**2J. Consideration to adopt Resolution 2025-24 for Development Stage and Final Stage Planned Unit Development and Resolution 2025-25 and Ordinance 845 for Rezoning to Mastercraft Planned Unit Development for Phased Industrial Development including Industrial Service and Industrial Self-Storage as Principle Uses in the I-2 (Heavy Industrial) District and adopting Summary Ordinance 845A for publication. Applicant: Tim Flander/Big Bear Holdings**

**Planning Case Number:** 2025-05

**Mastercraft Planned Unit Development  
Lot 1, Block 1, Oakwood Industrial Park 3<sup>rd</sup> Addition**

**LANDSCAPE PLAN**

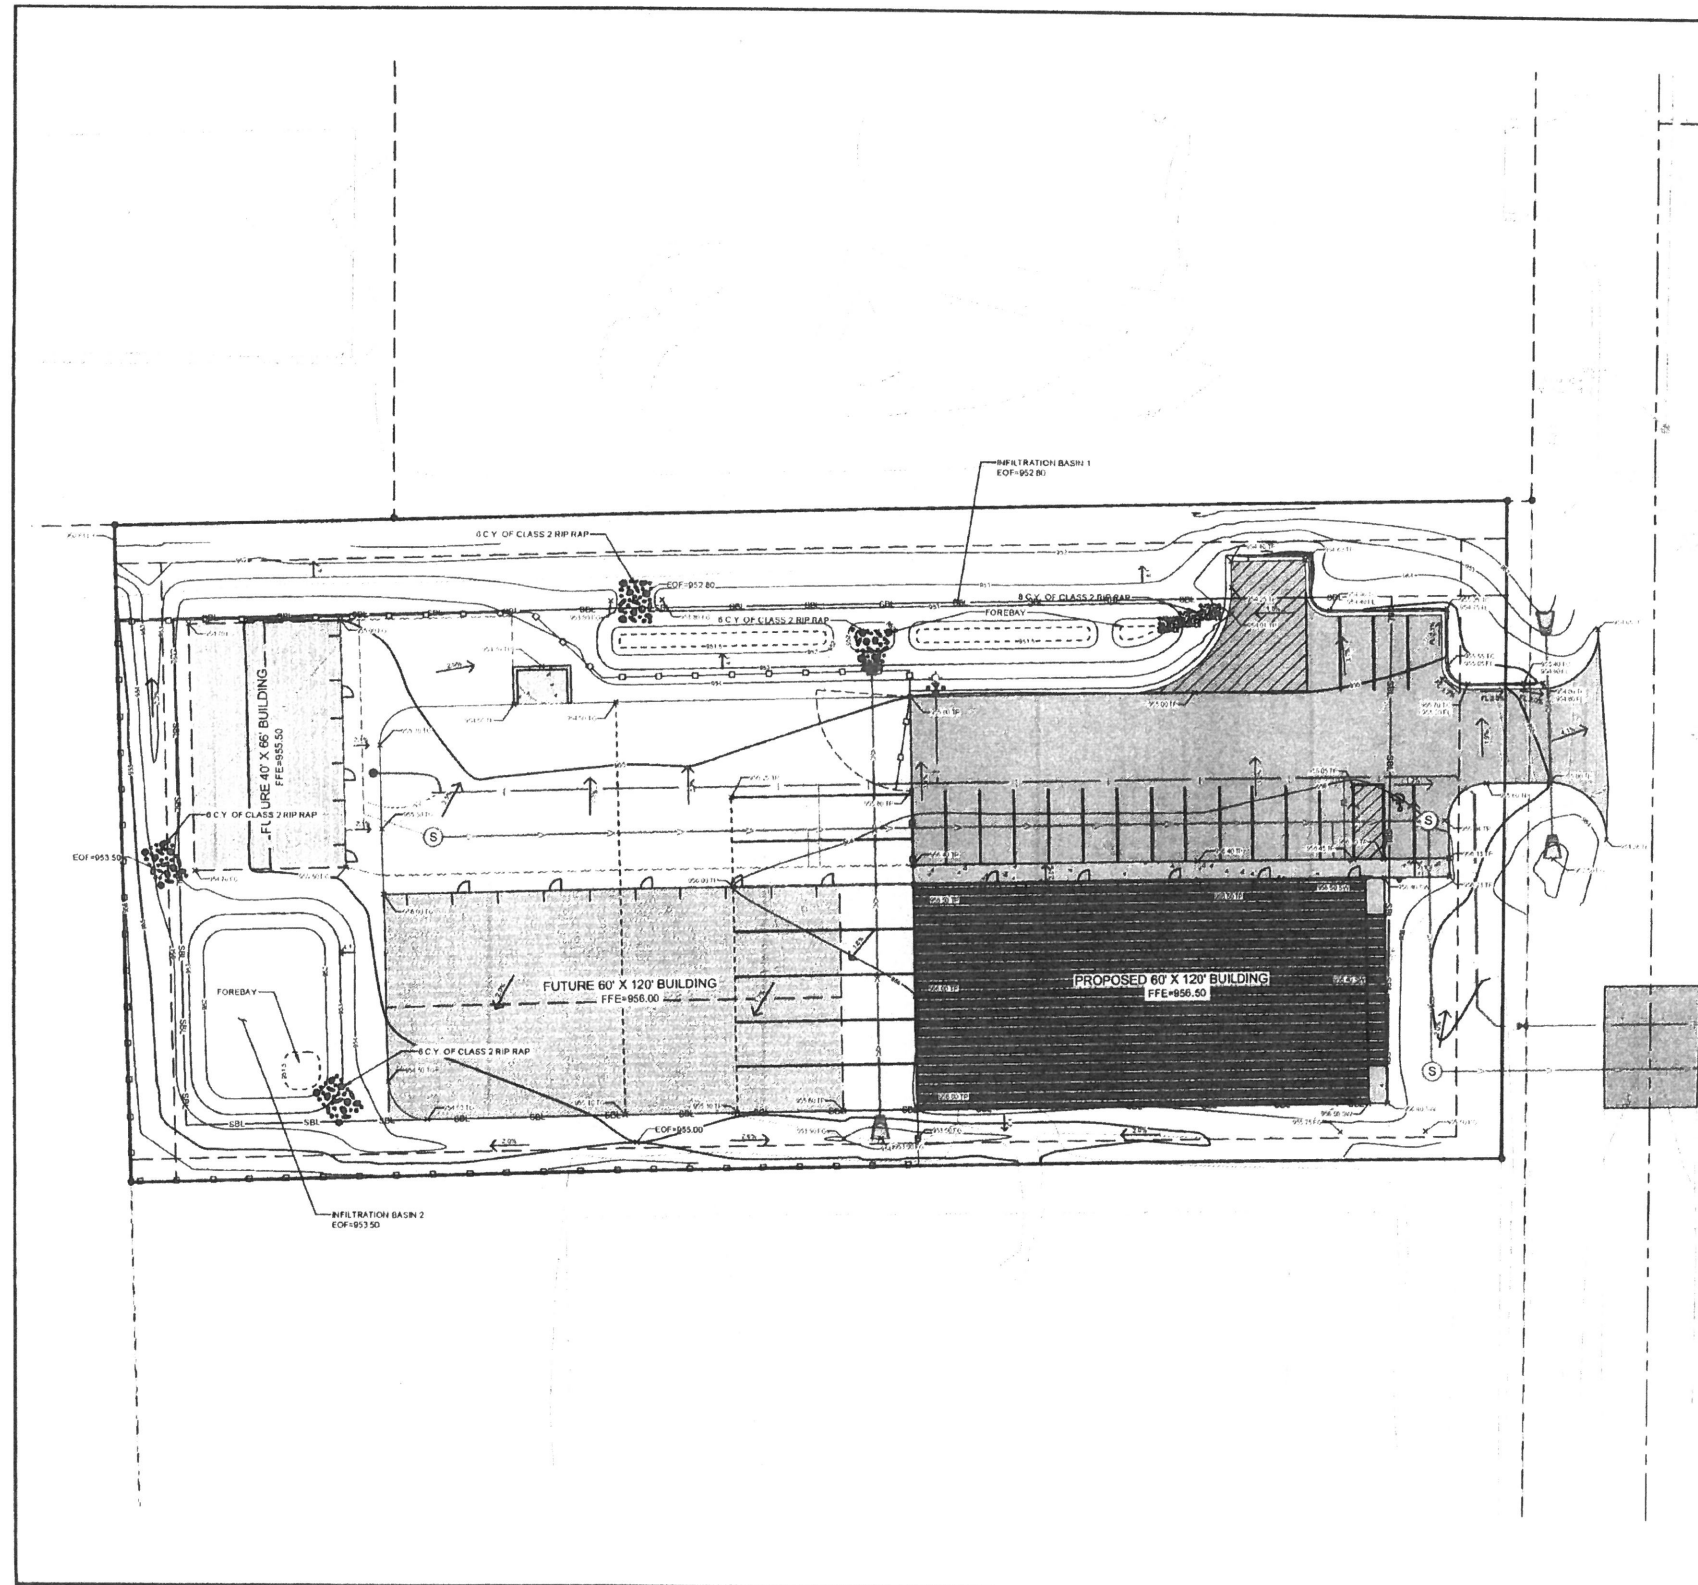
**Landscape.** The landscape plan originally provided consisted of a series of Black Hills Spruce along the north property line, along a proposed boundary fence. With the final stage plans, these trees were scaled back significantly from the original plan. While they were a positive addition to the site, land uses to the north are heavy industrial and technically do not require a planted buffer. The plan also includes a shrub foundation planting in front of the building, and other ornamental tree plantings. Otherwise, the ground surface is required to be planted with turf. The landscape plan meets the City's planting requirements for tree quantities and shrub

plantings for the site and building, but the retention of at least some of the original count of Black Hills Spruce is recommended to support the PUD flexibility in building materials and storage area allowances.

- B. Landscaping is constructed and maintained per plans provided with incorporation of the recommendation for 3-5 additional Black Hills Spruce along the north property line and turfgrass established in all areas not designated for pavement or storage/circulation.

PAGE TITLE:  
**FRONT ELEVATION**

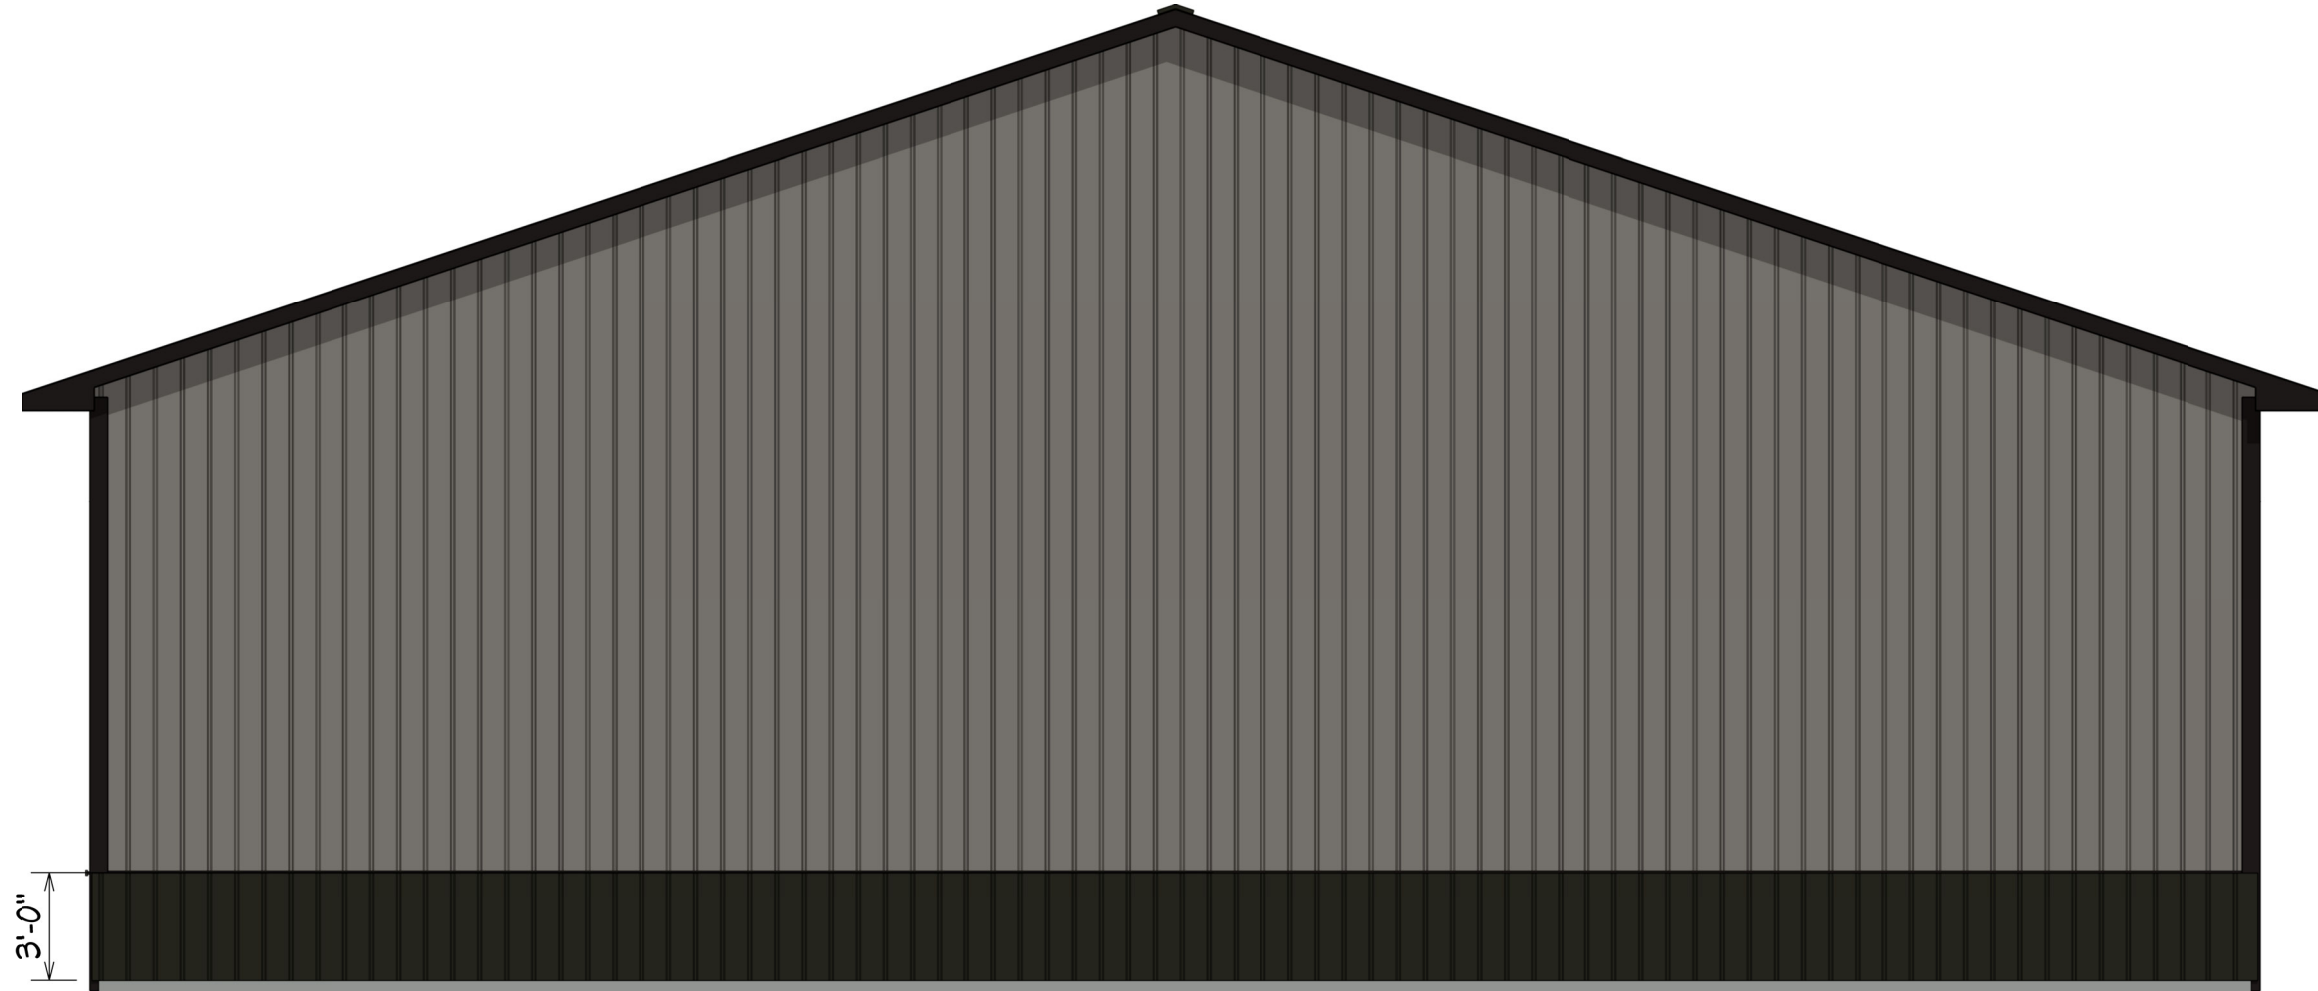
**Building Design/Materials.** Building materials for the structure are an aspect of departure from the zoning ordinance. Per code, building materials should be masonry on all sides, or a textured product to simulate masonry exterior materials. While the applicant relied on other prior buildings constructed in the general area as examples, the City's revised materials code prohibits the exposed ribbed steel. Most recent permit approvals in industrial zones relied on the updated code standards. The applicant proposes to use steel siding, but with a textured surface. On the front elevation, the applicant proposes a wainscot of cultured stone.

As a condition of approval at the prior review, the City modified its approval to incorporate the requested textured steel siding (not ribbed panels) on all four sides of the building and including masonry wainscot along the front (Fallon Avenue) face of the structure.
